ZAYO'S PRINEVILLE TO RENO PROJECT

CPUC MINOR PROJECT REFINEMENT FORM

Date Requested: 15 Oct 2024	Report No.: 10
Date Approved: 11/6/24	Approval Agency: Caltrans, in addition to CPUC
Property Owner(s): Caltrans (State Route 395 ROW)	Location/Milepost: PM M-2.7 to M-3.3 (S to N)
Land Use/Vegetative Cover: Ruderal (maintained highway shoulder near edge of pavement)	Sensitive Resources: Waterways at culverts to be avoided by boring underneath culverts. Cultural resources will still need to be avoided. (See project webmap.)

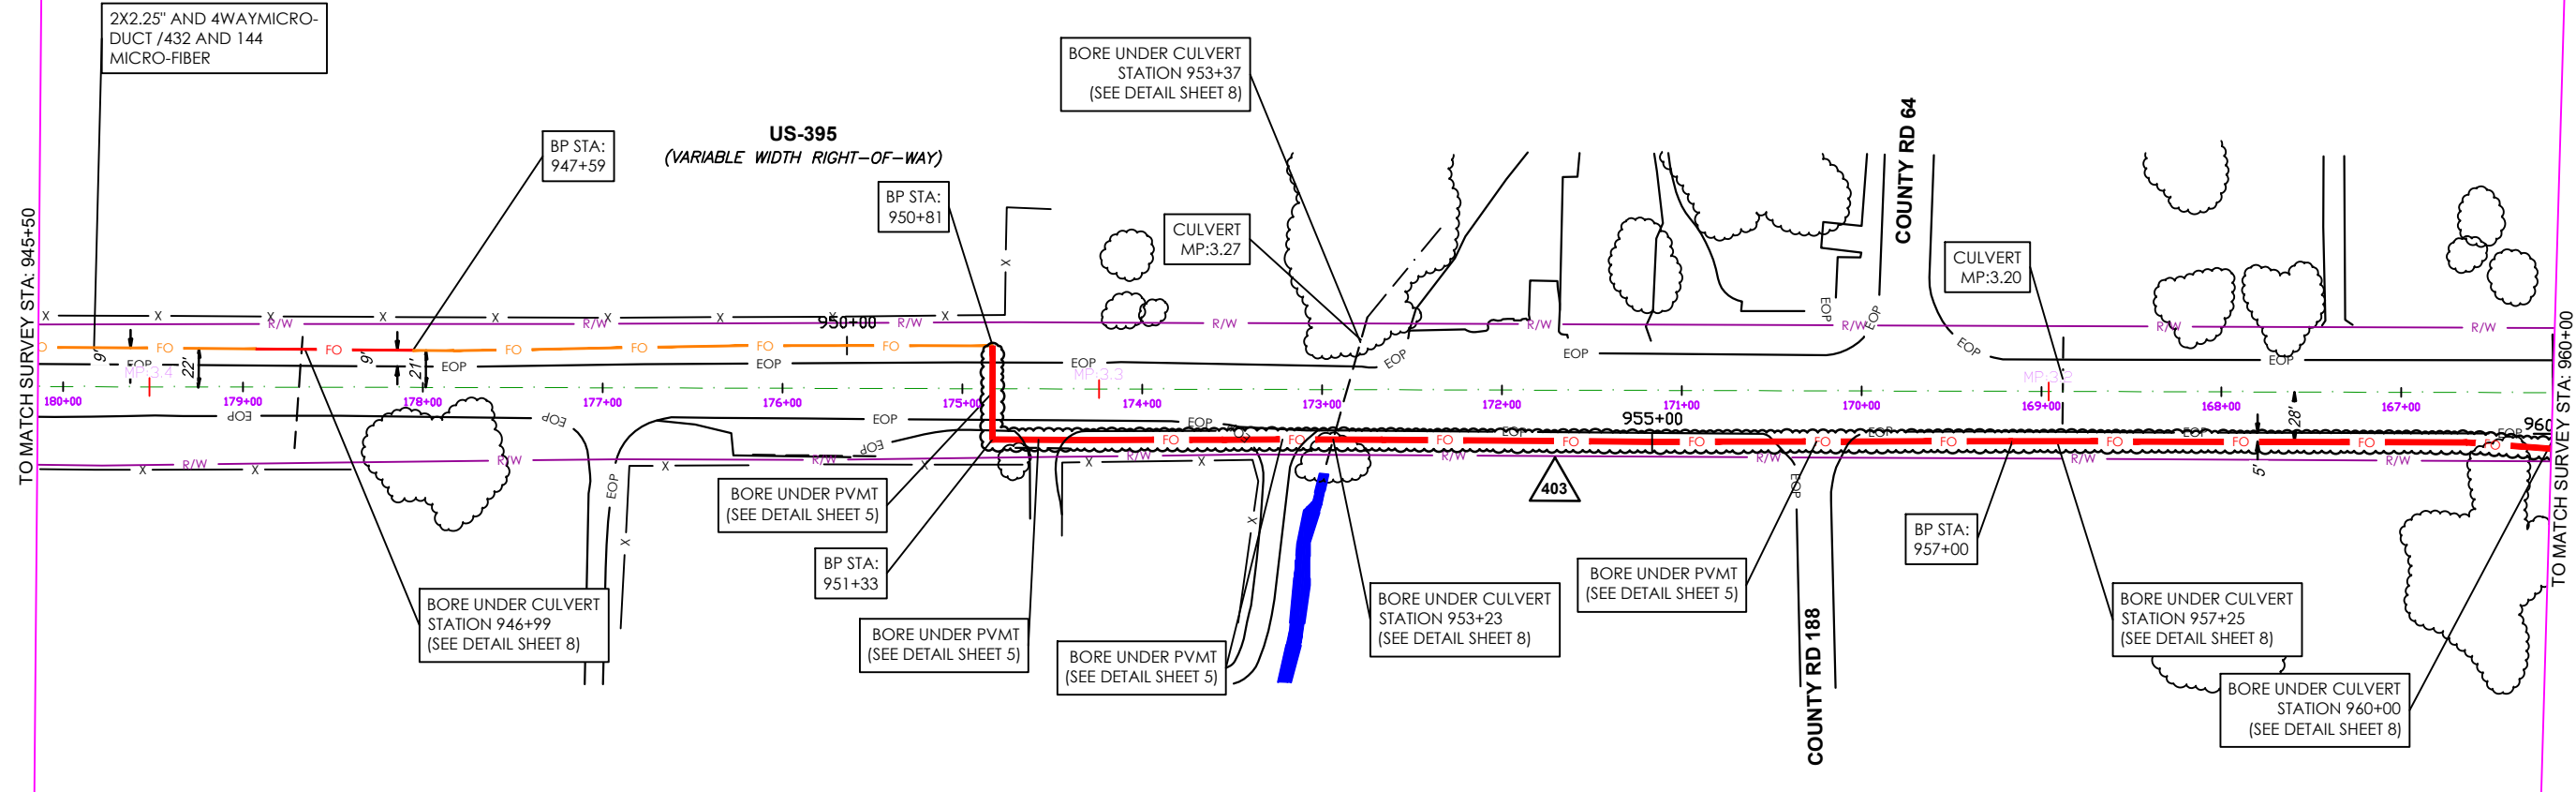
The proposed change is a shift of the fiber optic running line from previously submitted engineering drawings. The change entails shifting the running line through the town of Likely from the east side of the road to the west side of the road. The entire section will be bored, consistent with the approved plans. USA marks and discussions with property owners have revealed a number of utilities and abandoned fuel tanks in conflict with the alignment on the east side of the road. Shifting it to the west side will avoid these conflicts and decrease the overall impact to the businesses and residents, primarily located on the east side.

<u>Conditions of Approval or Reason for Denial:</u>	
The Applicable Conditions of Approval from the Project Conditions, Monitoring, Compliance, and Reporting Program apply to this request.	
Evidence of Caltrans approval to be supplied to CPUC prior to construction in this area.	
Prepared by: ECORP Consulting	Date: 11/6/24

RFI_0403,404,405,406_MP_M_AK74to75	
AK - ALTURAS TO JUMPER RIDGE RD	
SCALE: 1"=100'	SHEET NO.: 74 of 75
JOB NUMBER: UPR	DATE: 10/16/24
DRAWN BY: WP	TITLE: 100% REV

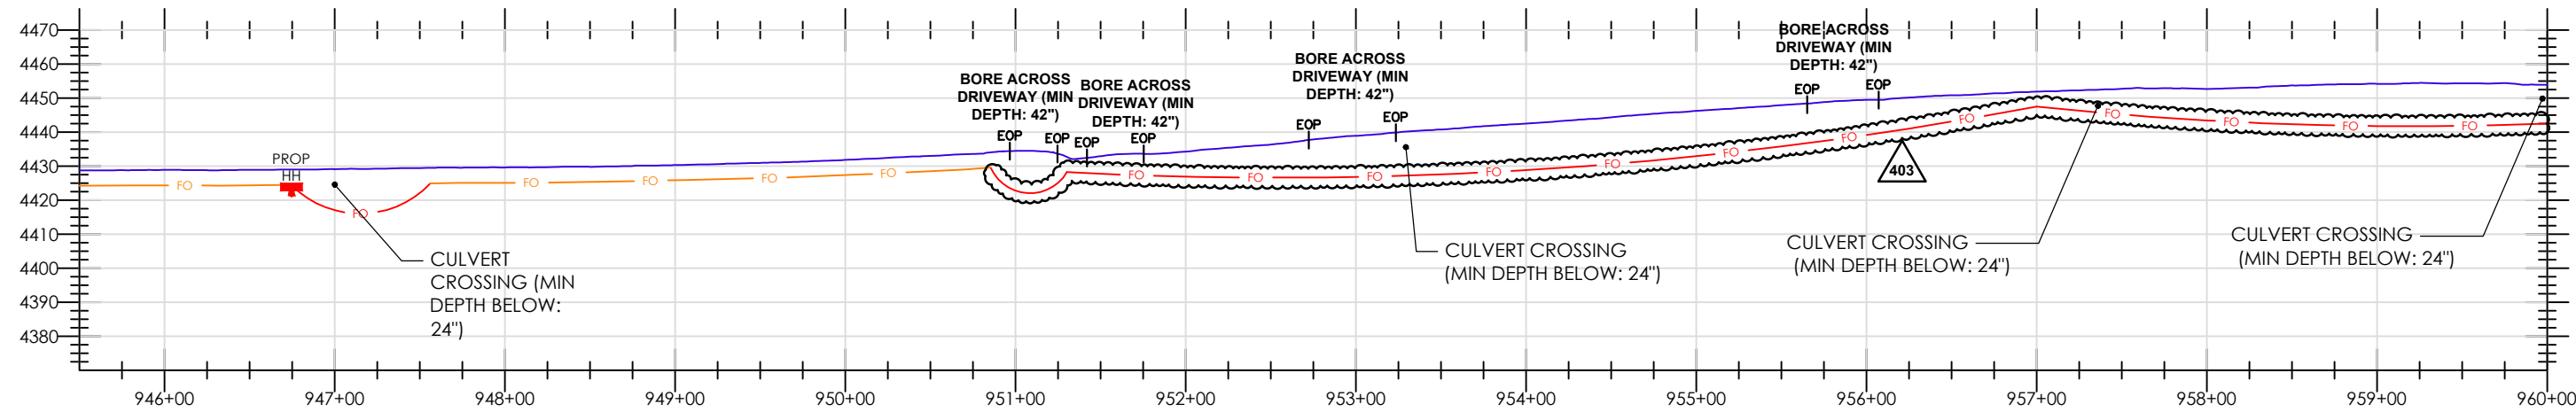
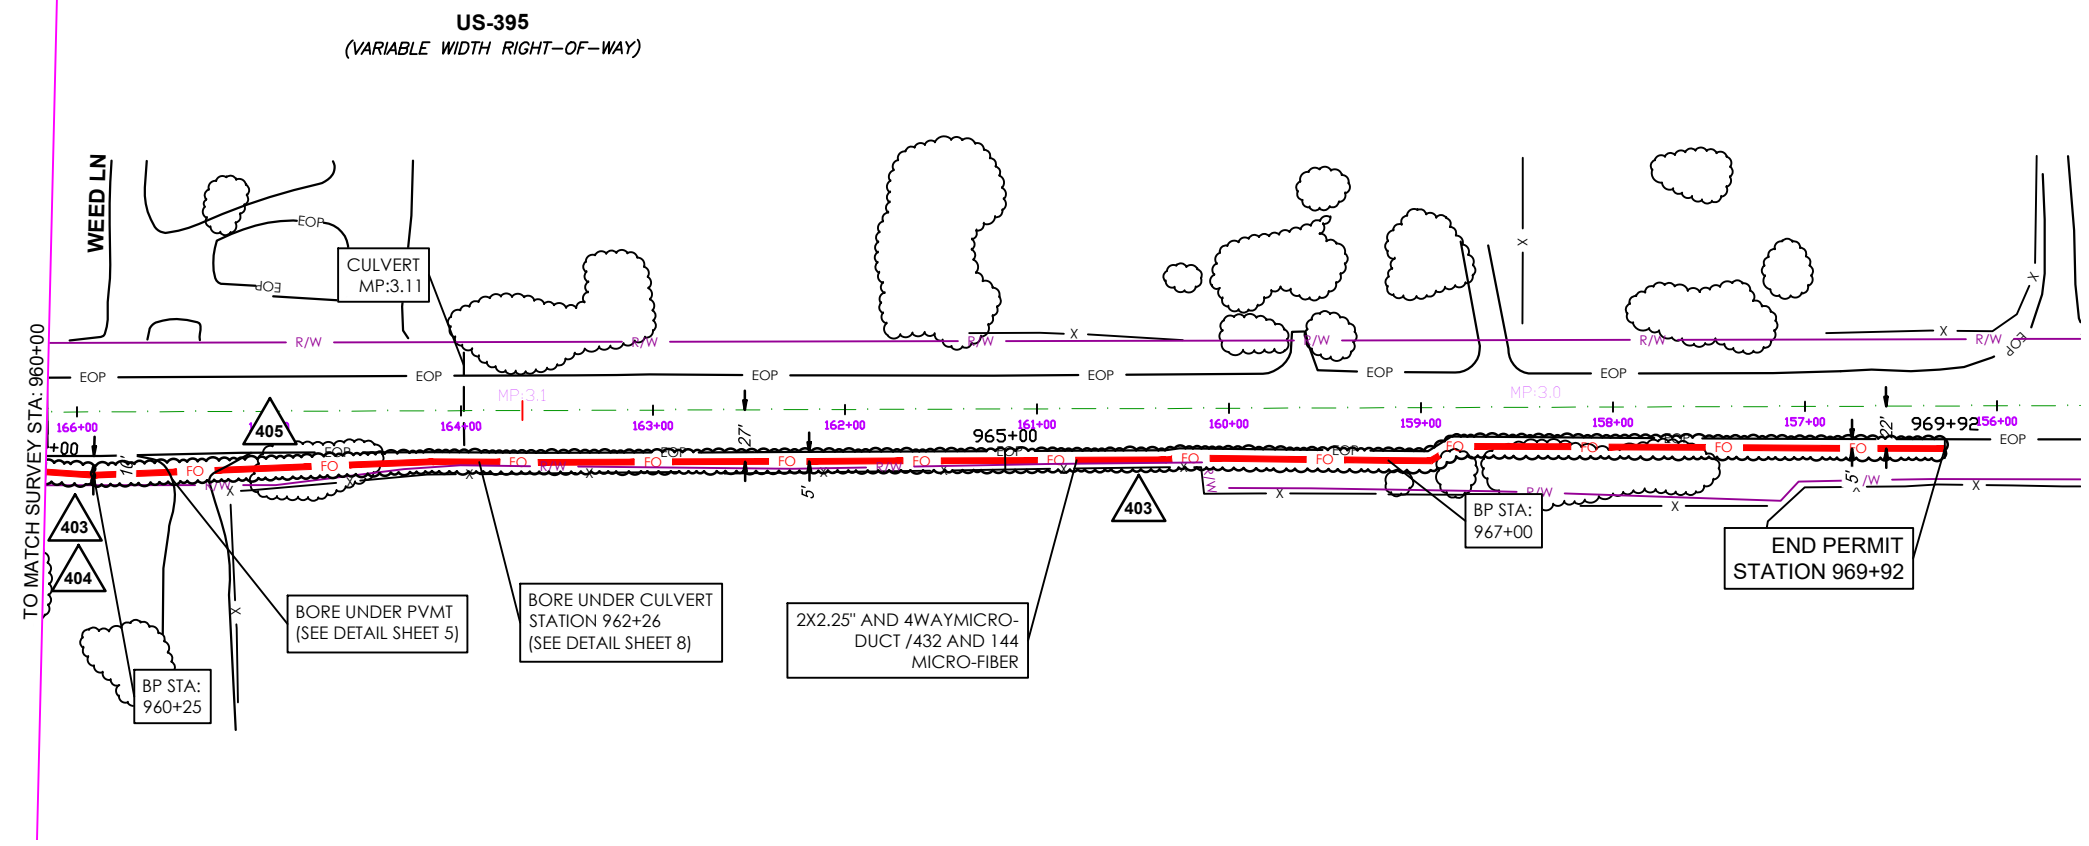
RFI NO. 0403 SHIFT R/L TO WEST SIDE 5 FT O/S EOP STA 950+81 TO STA 969+38	10/09/2024

SHEET NO.: 75 of 75

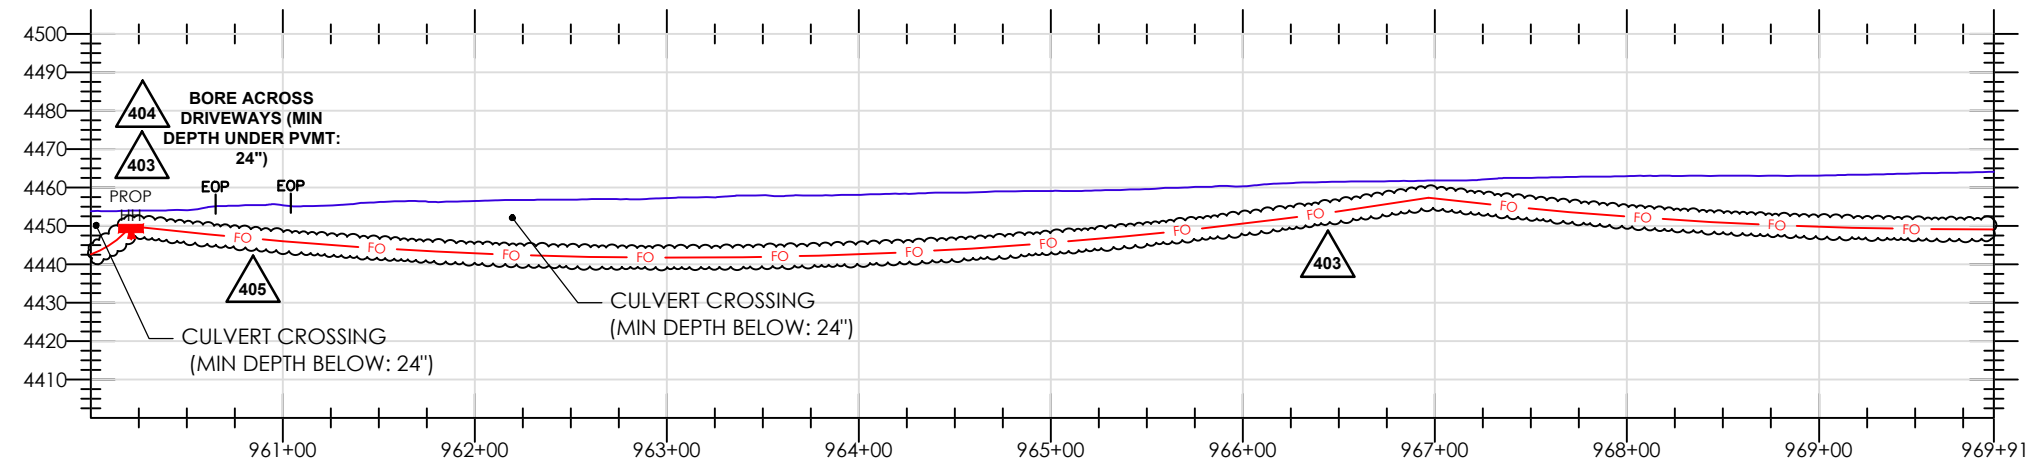
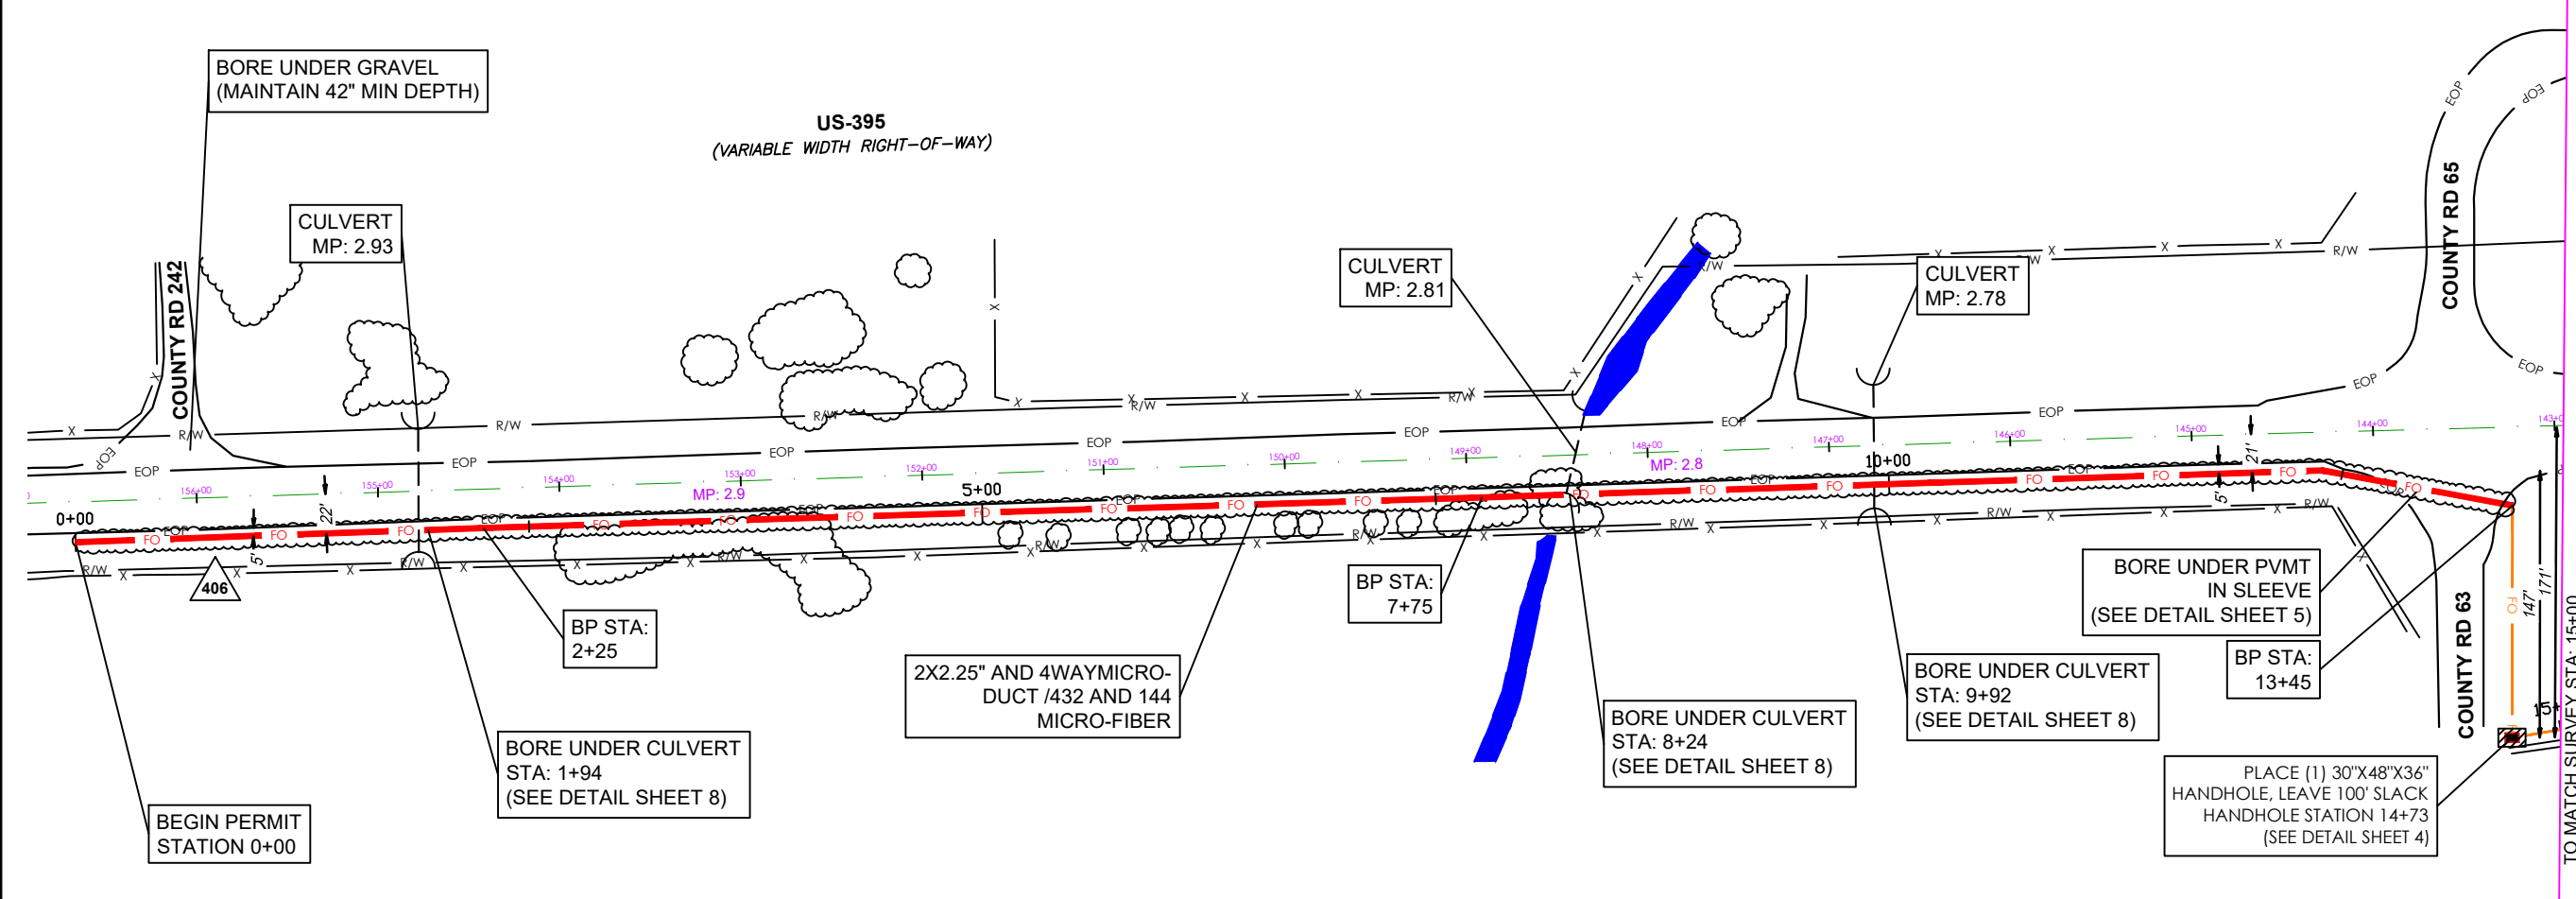
RFI NO. 0403 SHIFT R/L TO WEST SIDE 5 FT O/S EOP STA 950+81 TO STA 969+38	10/09/2024
RFI NO. 0404 BORE ACROSS THE STREET AND PLACE FRONTIER HH @ STA 960+10	10/09/2024
RFI NO. 0405 PLACE HH @ 10 FT O/S EOP TIE TO FRONTIER HH RFI 404 STA 960+75	10/09/2024

RFL_0406_MP_L_AL9	
AL - ALTURAS TO JUMPER RIDGE RD	
SCALE: 1"=100'	SHEET NO.: 9 OF 105
JOB NUMBER: UPR	DATE: 10/7/24
DRAWN BY: WP

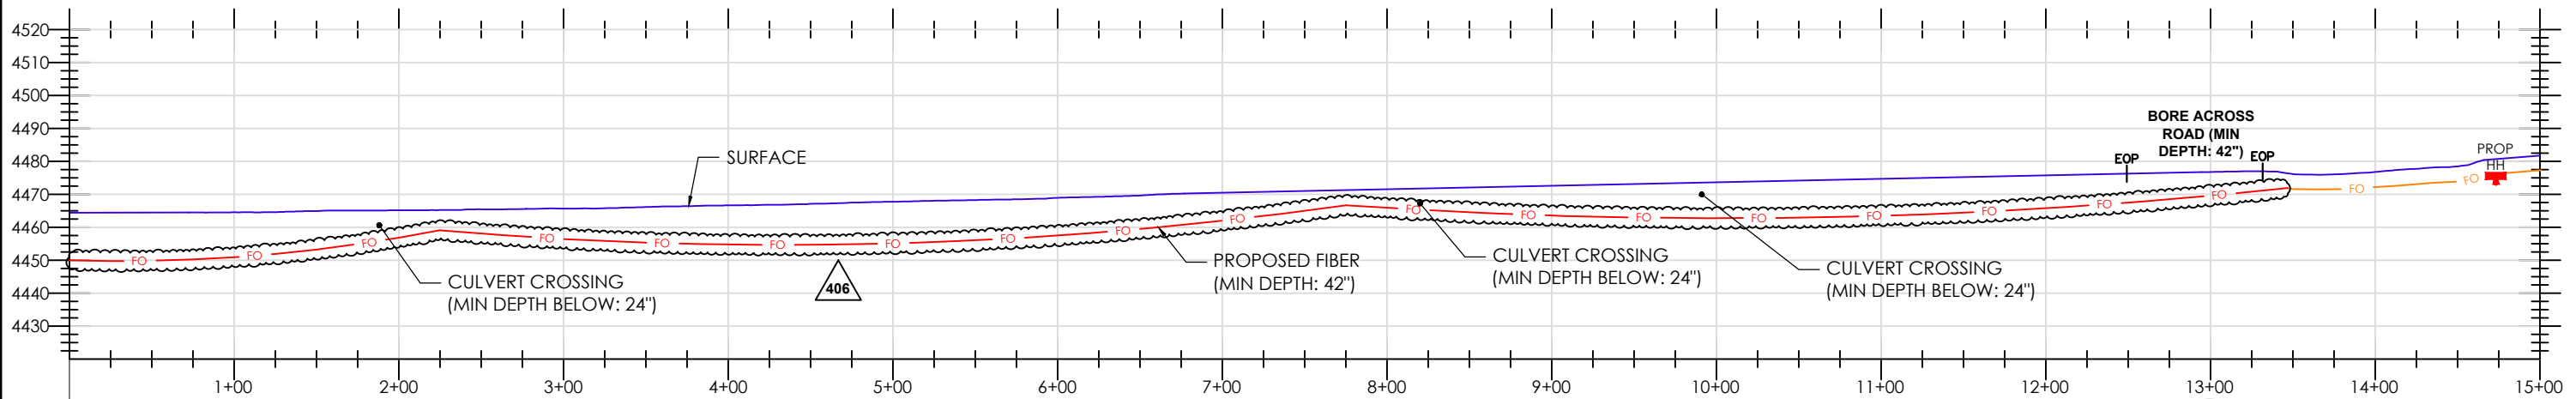
RFI NO. 0406 SHIFT R/L TO 5 FT O/S EOP STA 717+62 TO STA 745+00	10/08/2024
